Subject Replace Engine Oil Drain Plug

Application: 900 1990 1/2 – 1991 1/2

CATEGORY	
Maintenance	
SECTION	PAGE
1	30
ISSUE	CODE
05/93-0327	110

Service Directive

Figure 1. Drain Plug Location – For reference only

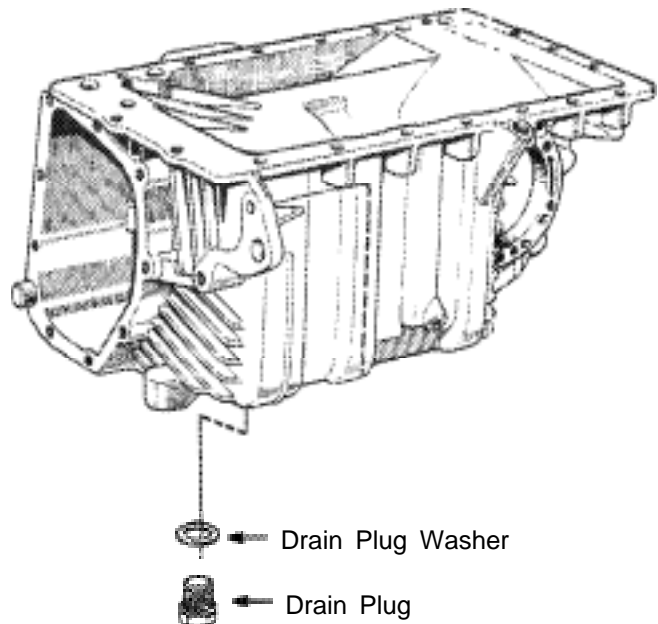
During mid-1991 900 production, the engine oil drain plug in the manual gearbox case was changed from 19 mm (wrench size) back to one with a 13 mm head. This change was made to reduce the possibility of overtightening the drain plug which can crack the gearbox case, Figure 1.

Figure 2. Replace 19 mm drain plug (B) with 13 mm plug (A). Use steel washer shown (do not use old design copper washer).

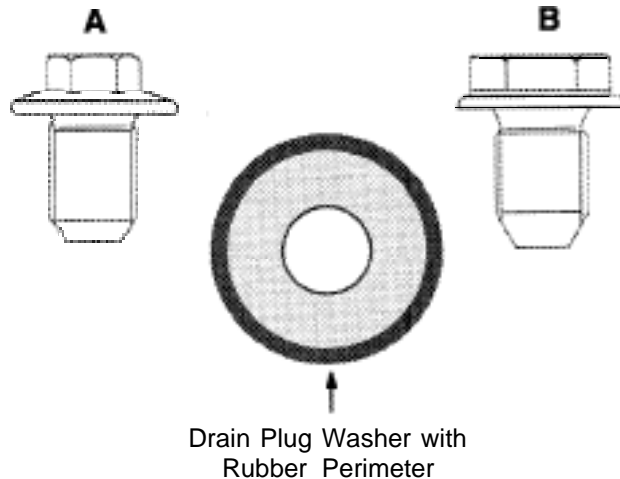
If not yet done, the 19 mm drain plug must be replaced with the 13 mm head drain plug. Do so at the next service opportunity, regardless of whether the car is scheduled for an oil change at that time.

13 mm Drain Plug P/N 87 31 762
 Steel Drain Plug Washer P/N 87 28 057

Torque Specification: 21-29 ft lb (29-39 Nm)

- 1. Replace the 19 mm drain plug with the 13 mm plug and steel drain plug washer. Torque to specification.
